ECE/TRANS/WP.29/GRE/2009/39
16 July 2009

REGULATION No. 53

Visibility of horizontal inclination adjustment system (HIAS) for motorcycles and glare

Proposal for Supplement 11 to the 01 series of amendments to Regulation No. 53

EXPLANATION ABOUT "THE HORIZONTAL INCLINATION", "THE BANK ANGLE"
AND THE ANGLE "δ".

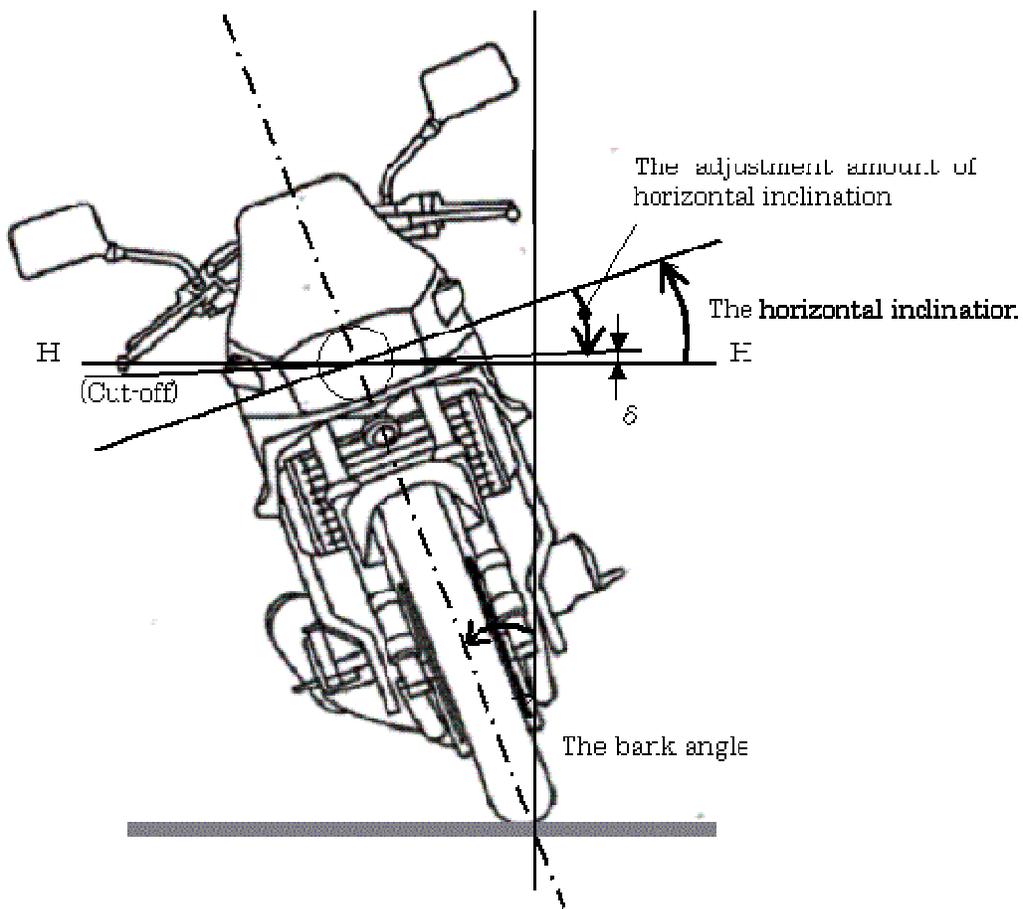
- "2.24. **"Horizontal inclination"** means the angle created between the beam pattern when the motorcycle is set as specified in paragraph 5.4., and the beam pattern when the motorcycle is banked (see drawing in Annex 6).

- 2.28. **"Signal generator"** means a device, reproducing one or more of the signals for system test."
- 2.29. **"HIAS test angle"** means the angle δ created by the headlamp cut-off line and HH line (in case of an asymmetrical beam headlamp, the horizontal part of the cut-off shall be used), (see drawing in Annex 6)."

Insert a new Annex 6, to read:

Figure 1. Description of the Function of the Inclination Angle adjustment-Type AFS

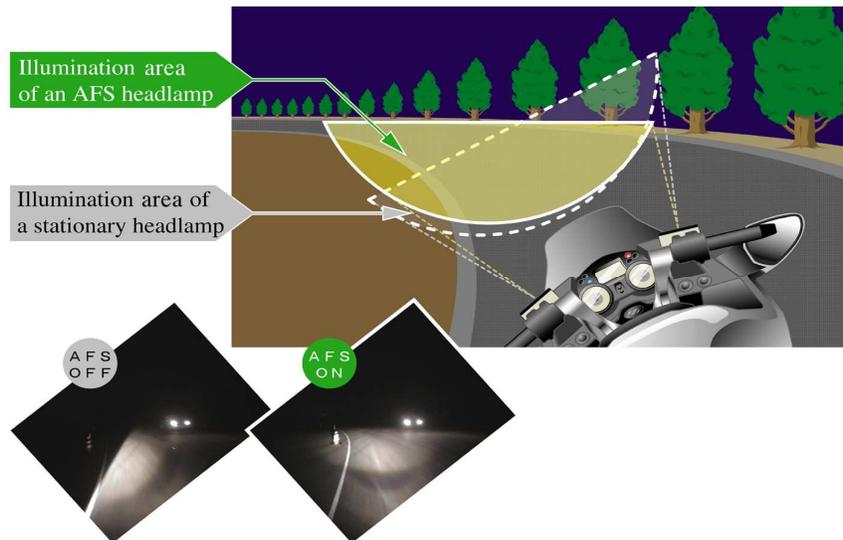
In the case of a motorcycle, due to its driving characteristics, the headlamp inclines with the vehicle when the vehicle is running on a curved road, narrowing the illumination area of the headlamp in the travelling direction. Therefore, by adjusting the variation of the headlamp's light distribution from that when the vehicle is upright (i.e.: in the standard condition), to keep the illumination area wide enough, the visibility is expected to improve.
